PUBLIC SCHOOL DEVELOPMENT STANDARD ADVISORY COMMITTEE

VIEWLANDS ELEMENTARY SCHOOL DESIGN DEPARTURE RECOMMENDATIONS

Project #3036282-SD

October 2, 2020

Exhibit 2 Proposed Height

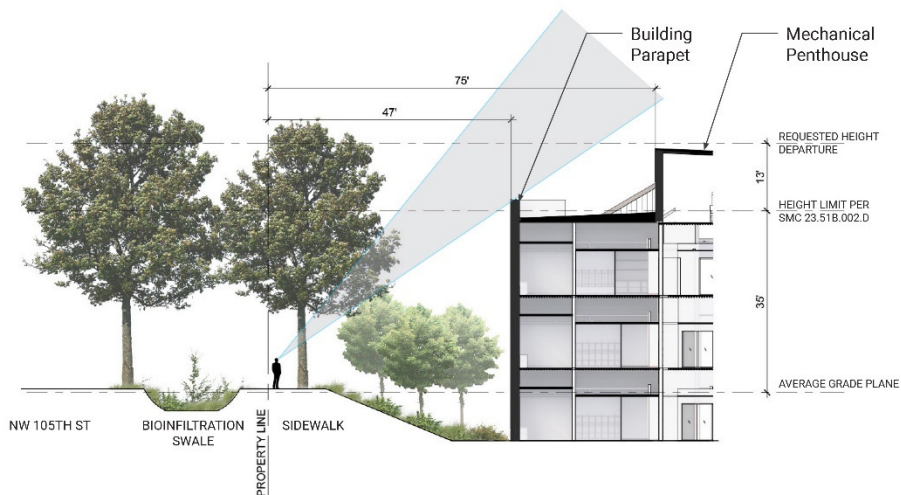
Departure Requested: 13 feet above the height limit.

While some commenters felt the building should be no taller than two-stories and questioned the City's methods for determining average existing grade, the design team was creative in using the steep grading of the property to hide the building. From the street, it will look like a one-story building.

Exhibit 4 Proposed On-Site Parking

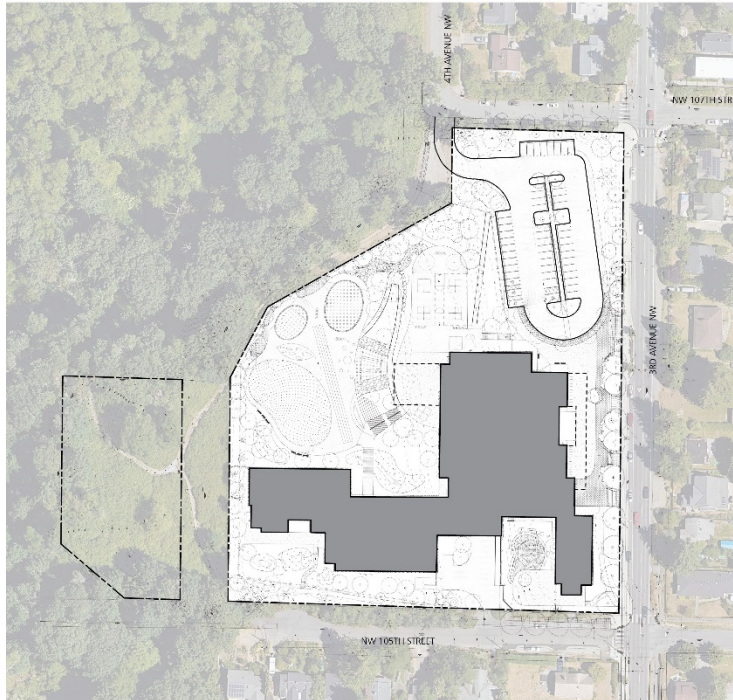
Departure Requested: to allow for 96 parking spaces less than the code required parking to be provided on-site. [146 required stalls – 50 proposed stalls = 96 stall departure requested]

Recommendation 2 – That the departure to allow less than required off-street parking be GRANTED as requested by the Seattle Public Schools without modification and with the following conditions:

- 1) **Transportation Management Plan (TMP):** Prior to the school reopening, the District and school Principal should establish a TMP to educate families about the access load/unload procedures for the site layout. The TMP should also encourage school bus ridership, carpooling, and supervised walking (such as walking school buses). The plan should require the school to distribute information to families about drop-off and pick-up procedures, as well as travel routes for approaching and leaving the school. It should also instruct staff and parents not to block or partially block any residential driveways with parked or stopped vehicles.

Exhibit 5 Proposed Long-Term Bicycle Parking

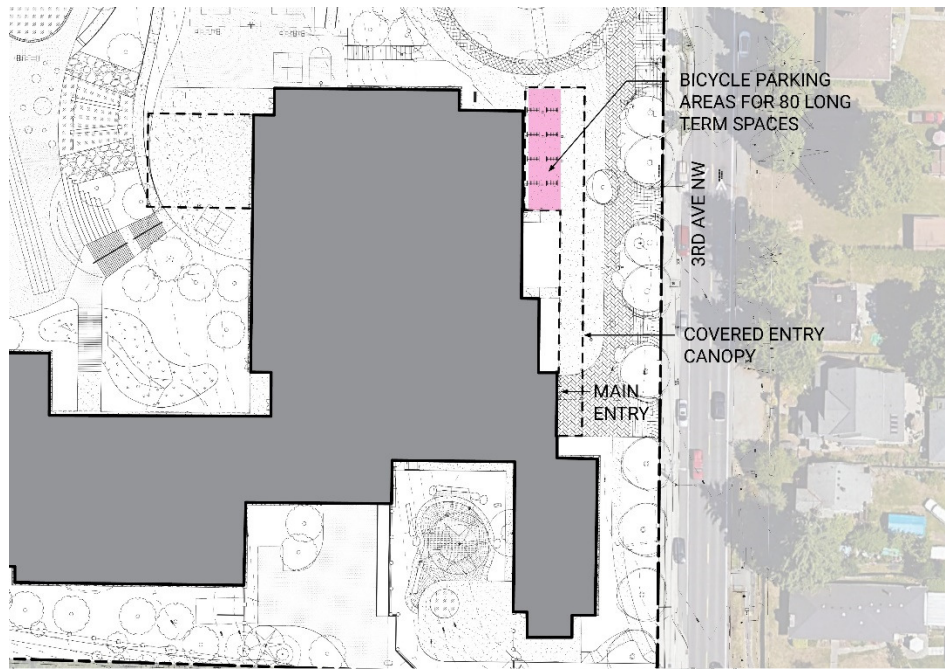
Departure Requested: to allow for 49 bicycle parking spaces less than the code required parking to be provided on-site. [129 required stalls – 80 proposed stalls = 49 stall departure requested]

Of the comments received on this departure, only one recommended it be outright denied due to its harm on the neighborhood. All other comments questioned whether the 89 bicycle parking spots offered was sufficient to meet the future demand of commuting to school by bike and allow the school community to grow into the number of bicycle parking stalls. As one commenter noted, the proposed long-term bicycle parking is a significant improvement over what is currently there.

Exhibit 6 Proposed Short-Term Bicycle Parking

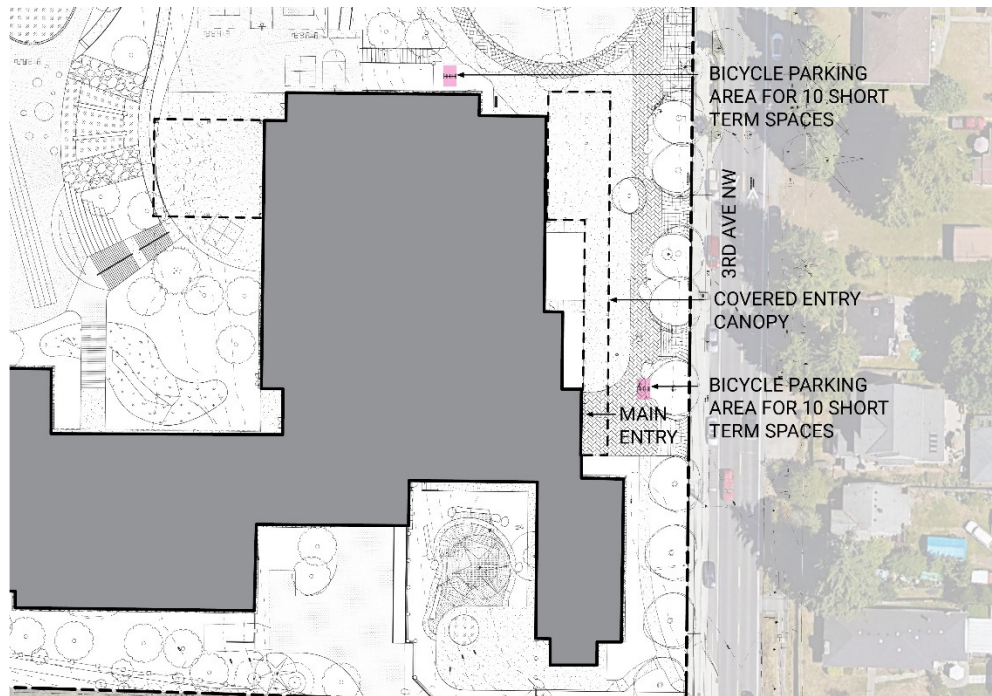
Departure Requested: to allow for 23 bicycle parking spaces less than the code required parking to be provided on-site. [43 required stalls – 20 proposed stalls = 23 stall departure requested]

Recommendation 4 – That the departure to allow less than required short term bicycle parking be GRANTED with the following modification:

- 1) **Seattle Public Schools provide at a minimum 50% of the code required number of short-term bike parking stalls**

Exhibit 7 Proposed Location of Long-Term Bicycle Parking

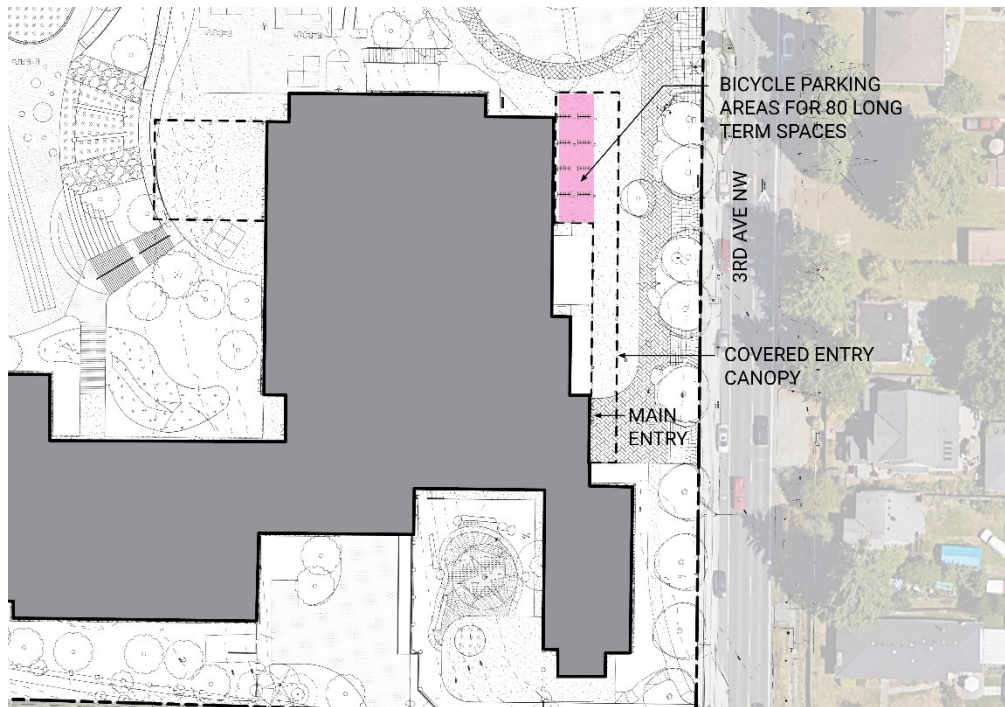
Departure Requested: Provide open bike racks for long-term bicycle parking rather than locked rooms, cages, or lockers

Recommendation 5 – That the departure to allow open bike racks for long-term bicycle parking rather than locked rooms, cages, or lockers be GRANTED with the following modification:

- 1) **Seattle Public Schools provide at a minimum 1 long-term bicycle parking space per classroom that meets the standards identified in SMC 23.54.015.K.2.**
